GOVERNMENT OF THE DISTRICT OF COLUMBIA
DEPARTMENT OF TRANSPORTATION

MEMORANDUM

SUBJECT: Zoning Commission Case No. 15-20 – Sursum Corda

Figure 1 Proposed ROW Changes

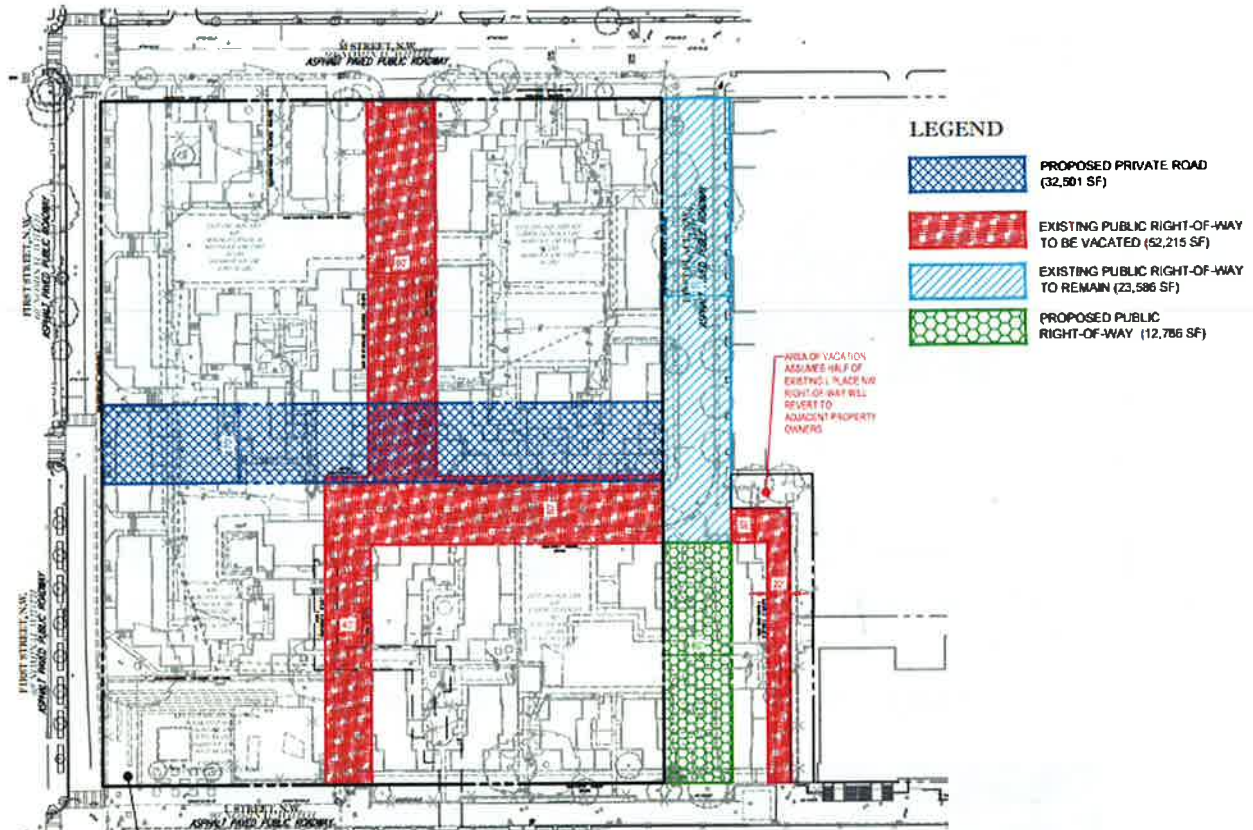
The 1st Place opening is proposed to be 60-feet. While this dimension does not meet DDOT's 75-foot standard for new right-of-way widths, the proposed width of the new 1st Street segment matches the existing width of 1st Street and is therefore appropriate.

Pierce Street, which currently exists west of 1st Street and east of North Capitol Street, is proposed to be opened as a 70-foot wide private street and will align with the public segment of Pierce Street to the west. The existing buildings to the east of the subject site do not permit the connection of Pierce Street to the east. Pierce Street is proposed to have one lane of vehicle travel in each direction and parking on both sides of the street. While private, Pierce Street must be designed and constructed to current DDOT standards. Of note, as Pierce Street is proposed as a private street, the District will not be responsible for street maintenance, snow removal, parking enforcement, and other services the District provides to public streets. Pierce Street will be constructed as part of Phase 1.

L Street is historically a 90-foot ROW, but was narrowed in the 1960s to its present ROW width of approximately 40 feet. This narrow existing ROW does not allow for a full typical District street section, including sidewalks and tree boxes of both sides of the street, two-way traffic, and curbside parking. The ROW is further constrained to the east of the site by stairs from Mount Airy Baptist Church that project about 8-10 feet into the limited ROW. Re-establishment of a full L Street section requires the extension of the street to the south. The Severna just to the south of the subject site set back their development to preserve adequate land for the eventual re-establishment of L Street, which requires the redevelopment of the two properties to the east of the Severna. The Applicant proposes L Street as two-way operations between 1st Street and 1st Place and one-way eastbound between North Capitol Street and 1st Place, which is appropriate given the limited ROW. The Applicant will also construct the public space along L Street between 1st Place and 1st Street to current DDOT standards. To facilitate the Applicant's vision for L Street, traffic signal and pedestrian improvements are needed at the intersection of North Capitol Street & L Street. These improvements are discussed in the Mitigations section.

1st Street, too, is historically a 90-foot ROW, but was narrowed in the 1960s to its present ROW width of 60 feet. The 30-foot segment of former ROW was divided between the Sursum Corda Cooperative and the federal government under the ownership of the National Park Service (NPS). The eastern edge of the existing ROW roughly aligns with the future eastern curbline of 1st Street, which the Applicant proposes to widen in order to facilitate two-way operations (one lane in each direction) and a parking lane on the west side of the street. This leaves no ROW on the east side of 1st Street for a typical sidewalk section, including street trees and a sidewalk. As present time, the Applicant proposes to set back their development to the historic ROW line and improve the land between the eastern curbline and the building line to current DDOT standards.
